Response to RFI Letter regarding Development Application DA/1007/2022 12 Lloyd George Avenue, Winston Hills

"Demolition of existing structures, removal of trees and construction of a two storey dwelling including basement parking."

Figure 1 – Excerpt from proposed landscape plan (Vision Dynamics, 2023)

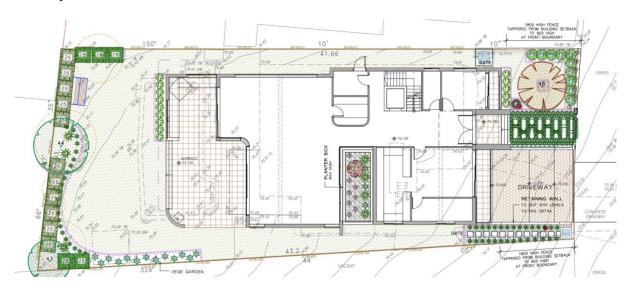
The proposed dwelling denotes a unique style with a flat roof and a basement that does not appear to be in keeping with the existing streetscape and would result in a development that would stand out in contrast to existing dwellings.

The proposed basement avoids any possibility for a reasonable open character front yard which is also consistent with the Winston Hills Special Character Area.

Therefore, plans detailing the façade and the appearance of the dwelling from the street are to be amended which includes the removal of the proposed basement to denote a more consistent appearance with the existing streetscape and Special Character Area.

The revised plans propose generous landscaping within the front setback, with the entire front garden except for the driveway featuring landscaped area. A paved pedestrian pathway was previously proposed, however, this has now been removed. The revised proposal no longer includes a development that results in the "loss of open character to front yards", better complying with the characteristics of the Winston Hills Special Character Area compared to the original design.

The upgraded landscaping will also assist to soften the perceived appearance of the dwelling house itself, particularly the proposed new 'Indian Summer' tree in the front yard which is capable of growing to 5 metres. The site benefits from a vacant landscaped strip of land along its western boundary which also offers visual relief. Combined with the articulatory details along the front façade, the flat roof will be less discernible.

Figure 2 – Aerial Map with properties varying the 30% rear setback control marked (NearMaps, 2023)

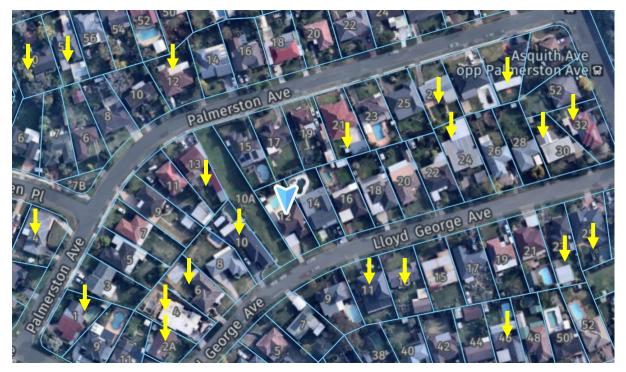
Section 3.1.3 of Parramatta Development Control Plan 2011 requires dwellings to be provided with a rear setback that is equal to 30% of the length of the site. The proposed dwelling denotes a rear setback of 8.51m or 20.4% to the rear boundary which is non-compliant with the 30% control. To ensure the development is consistent with the existing built form in the area and to allow for a continuous vegetative corridor the plans are to be amended to comply with the minimum 30% control or 12.49m.

Alternatively, further justification would be required demonstrating approved non-compliant rear setbacks within the immediate locality.

The PDCP 2011 requires a numerical rear setback of 30% of the site length, which equates to 12.498m for the eastern boundary and 12.96m for the western boundary at 12 Lloyd George Avenue. A rear setback ranging from 8.512m to 9.739m is proposed, which is considered to be acceptable upon merit given the strong prevalence of similar variations in the immediate locality and the high quality planning outcome proposed for the property.

As marked in figure 2, a substantial number of sites within the immediate locality display a variation of the 30% minimum rear setback controls. Specific Development Applications where City of Parramatta Council have recently approved such variations in Winston Hills include:
